Re: Rule 309.e. Colorado Parks and Wildlife's Consultation Summary

Crestone Peak Resources (Operator)
OGDP Name: State Sunlight-Long Pad
Form 2A Number(s): 404012825
Docket Number: 241200313

Figure 1 - Adaptations’ NLF sightings 9/9/25 (red X). The blue polygon is the proposed location, while the white polygon is a 500-foot buffer.

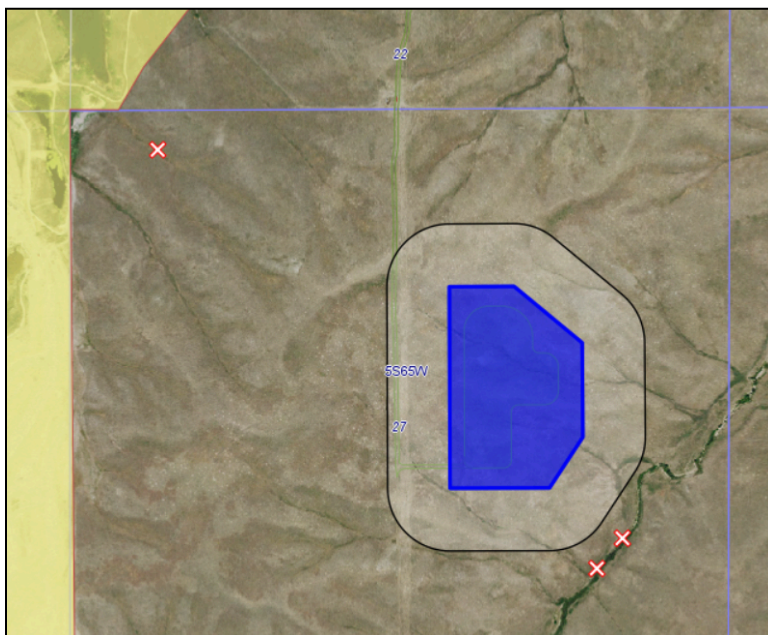
Furthermore, a 9/9/25 survey by a consulting firm (Adaptation Environmental) hired by the private advocacy group Save the Aurora Reservoir (STAR) observed NLFs also along Black Shack Creek (at least 700 feet southeast of this Location), as well as 0.49-mile northwest of the Location approaching Aurora Reservoir (see Figure 1 below).

- One testimony discussed the 9/9/25 NLF survey, which was sent to CPW on 9/23/25. It documented the presence of NLF about 0.14 miles SE of the Location along Black Shack Creek and 0.49 miles NW of the Location near the southern tip of Aurora Reservoir.

- CPW responds that this data matches existing CPW and HWA data that NLFs are temporarily foraging throughout these uplands. However, this data, plus the existing data from CPW and HWA, led CPW to ask for culverts and silt fencing above to reduce mortalities and to ensure NLF movement can continue throughout the development phases and during subsequent production activities.

Figure 2 - iNaturalist NLF sighting 7/2024 (red X).

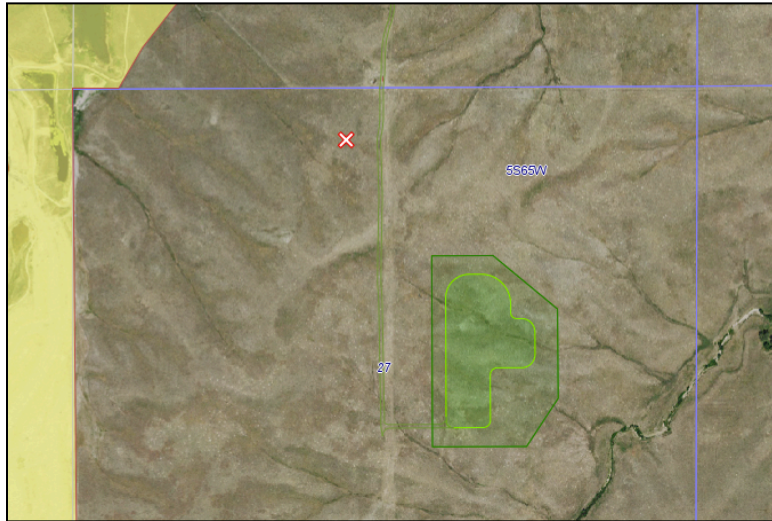
further below). Furthermore, iNaturalist³ recorded a NLF 0.23-mile NW of this Location in July 2024 (see Figure 2).

The abundance of long-term and recent data points from different surveyors confirms that NLFs are present immediately in Black Shack Creek (outside the 500' buffer adjacent to the Location), upstream of this Location (even into the western neighborhoods in 2020 and Sept. 2025), and downstream approaching E. Quincy Avenue, downstream of Aurora Reservoir on both sides of Quincy, and along Coal and Box Elder creeks to the east.
